FirstEnergy Nuclear Operating Company

Subject: License Amendment Application to Support Mark B-HTP Fuel design for Cycle 15  
(License Amendment Request No. 05-0002)

**DAVIS-BESSE NUCLEAR POWER STATION  
EVALUATION  
FOR  
LICENSE AMENDMENT REQUEST NUMBER 05-0002**

**Subject:** License Amendment Application to Support Mark B-HTP Fuel Design for Cycle 15

Figure 2.1-1 Reactor Core Safety Limit

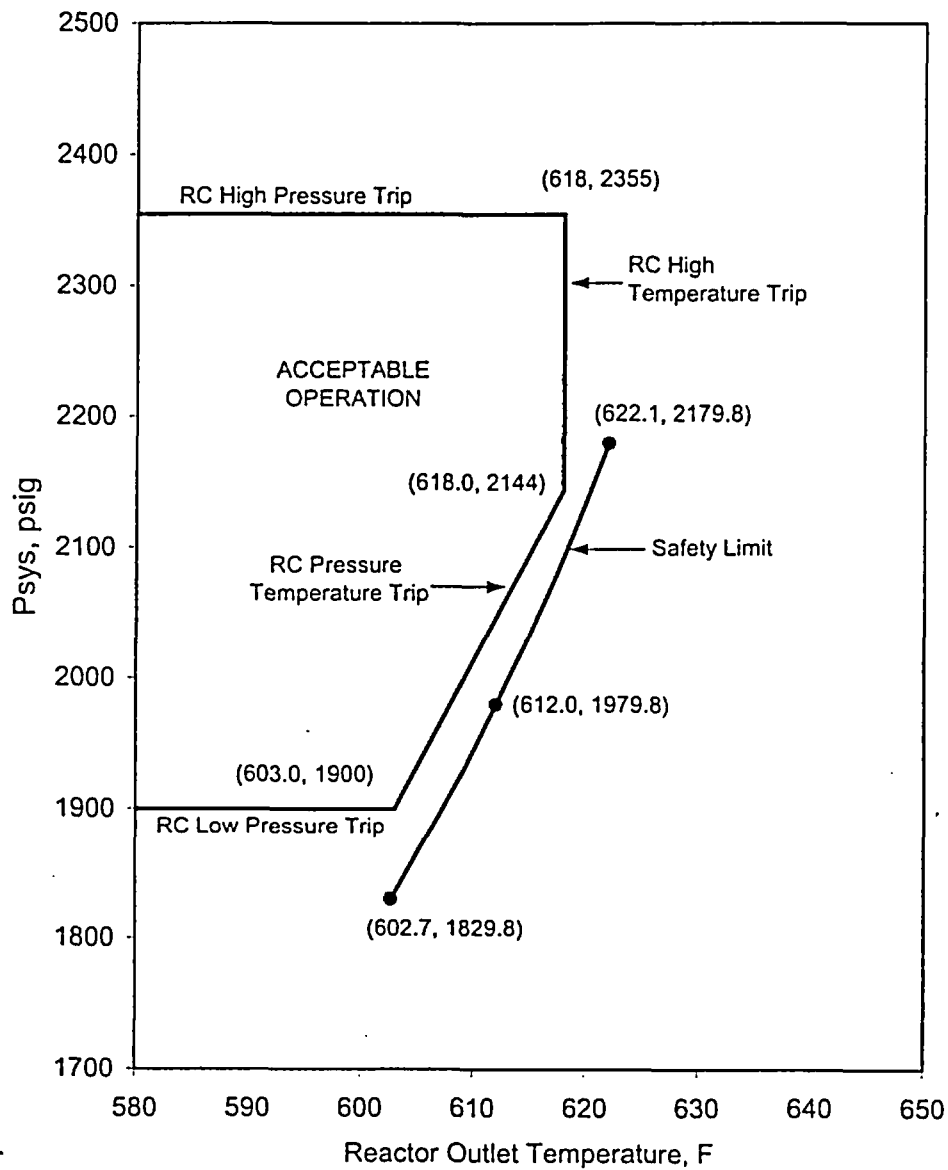
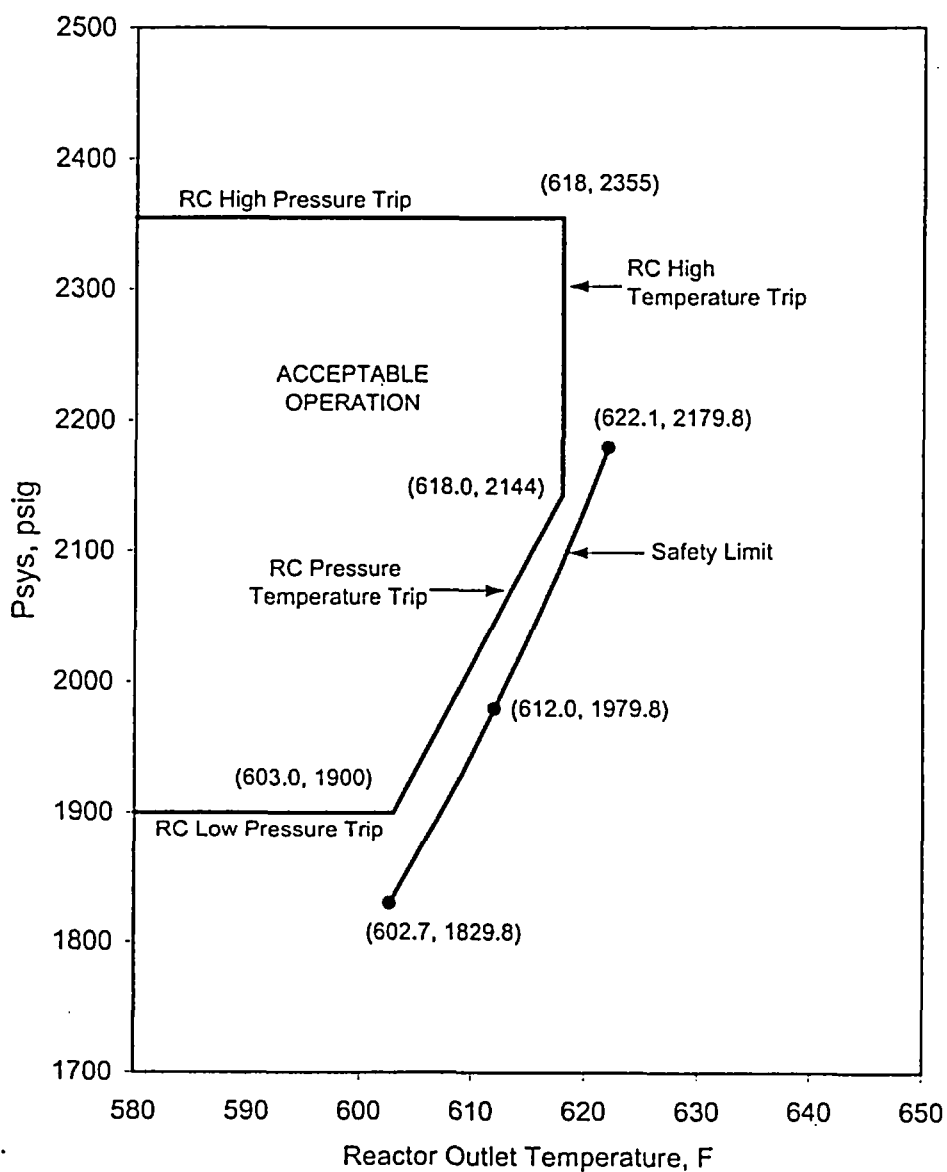
TS Section 2.1.1 states that the combination of reactor coolant core outlet pressure and outlet temperature shall not exceed the safety limit shown in Figure 2.1-1, "Reactor Core Safety Limit." It is proposed to revise Figure 2.1-1 to reflect implementation of a new fuel design in Cycle 15.

The proposed revision to TS Figure 2.1-1 is in accordance with updated analyses in support of the proposed new fuel design. These analyses showed that more restrictive reactor core safety limits are appropriate. Proposed TS Figure 2.1-1 contains the limiting reactor core (DNB-based) safety limit as well as the corresponding variable low pressure trip setpoint that assures protection for the safety limit. The reactor core safety limit defined for Cycle 15 is based on the BHTP CHF correlation and accommodates the necessary DNB margin to offset the transition core DNB penalty for Cycle 15 as well as subsequent cycles with the same number or additional Mark B-HTP fuel assemblies. In Figure 2.1-1, the proposed new Safety Limit appears slightly to the left of the existing curve. This corresponds to a reduction in the Safety Limit Reactor Outlet Temperature for each corresponding  $P_{sys}$  depicted on the figure. To maintain margin between the Safety Limit and the "RC Pressure Temp Trip," the "RC Pressure Temp Trip" curve has also been moved to the left, resulting in a reduction in the "Acceptable Operation" area depicted on the curve. Therefore, accommodation of a more restrictive reactor core safety limit results in a more restrictive variable low pressure trip setpoint as compared to the TS associated with Cycle 14 operation. The analyses for establishing the new Safety Limit were performed using NRC-approved methodology and NRC-approved thermal-hydraulic code. Since the limiting reactor core safety limit is based on applying the BHTP CHF correlation with its design limit of 1.132, the same degree of DNB protection will be provided as for the current Cycle 14 operation, which uses the BWC CHF correlation (BAW-10143P-A, *BWC Correlation of Critical Heat Flux*, Reference 4) with a design limit of 1.18. The new safety limit basis contains the same magnitude of DNB protection as the existing Cycle 14 Safety Limit, therefore the proposed change will have no adverse effect on nuclear safety.

REPLACE FIGURE  
(SEE ATTACHED PAGE)

Bases Figure 2.1 Pressure/Temperature Limits at Maximum Allowable Power for Minimum DNBR

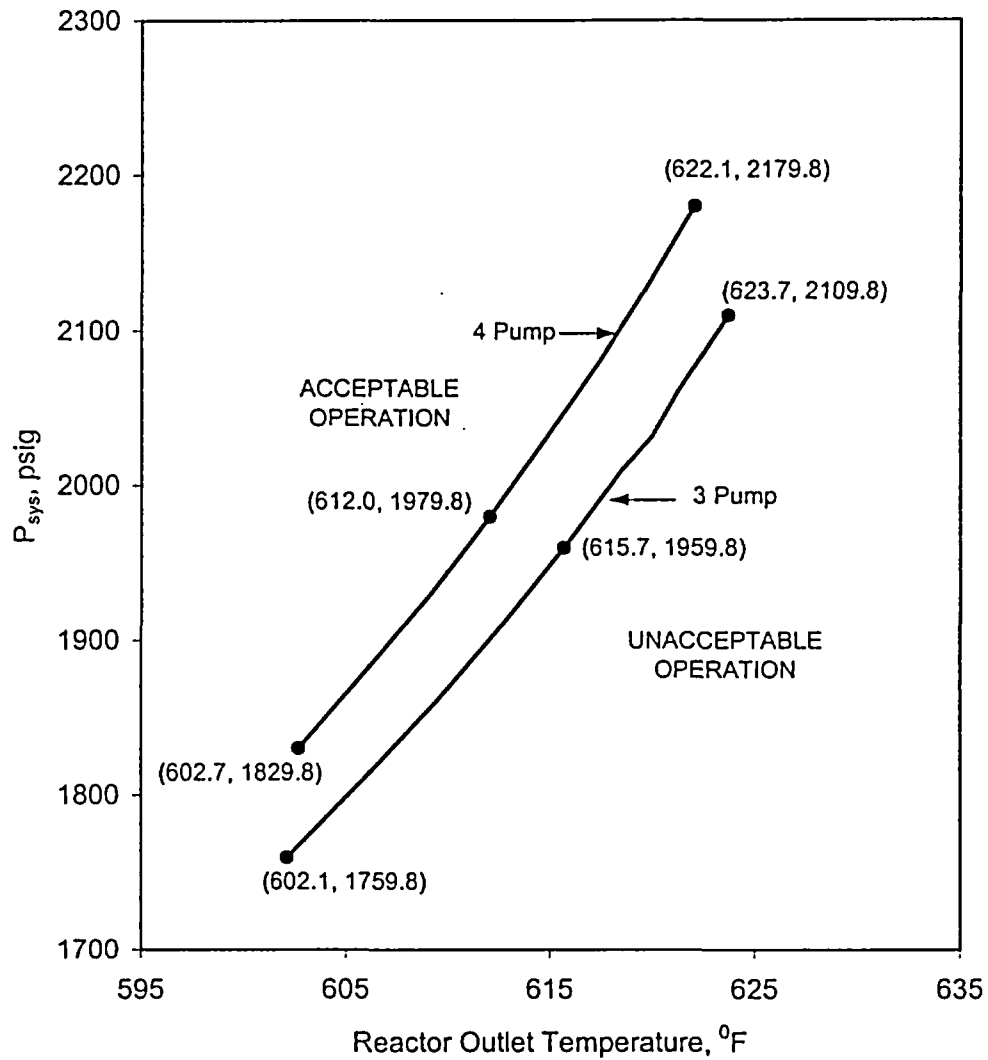
The curve of Figure 2.1-1 is the most restrictive of all possible reactor coolant pump-maximum thermal power combinations shown in BASES Figure 2.1. The curves of BASES Figure 2.1 represent the conditions at which a minimum DNBR equal to the DNBR limit is predicted at the maximum possible thermal power for the number of reactor coolant pumps in operation or the local quality at the point of minimum DNBR is equal to the corresponding DNB correlation quality limit (+22% (B&W-2), ~~or~~ +26% (BWC) or +34% (BHTP)), whichever condition is more restrictive.

For the curve of BASES Figure 2.1, a pressure-temperature point above and to the left of the curve would result in a DNBR greater than 1.30 (B&W-2), ~~or~~ 1.18 (BWC) or 1.132 (BHTP) and a local quality at the point of minimum DNBR less than +22% (B&W-2), ~~or~~ +26% (BWC) or +34% (BHTP) for that particular reactor coolant pump situation. The DNBR curve for three pump operation is less restrictive than the four pump curve.
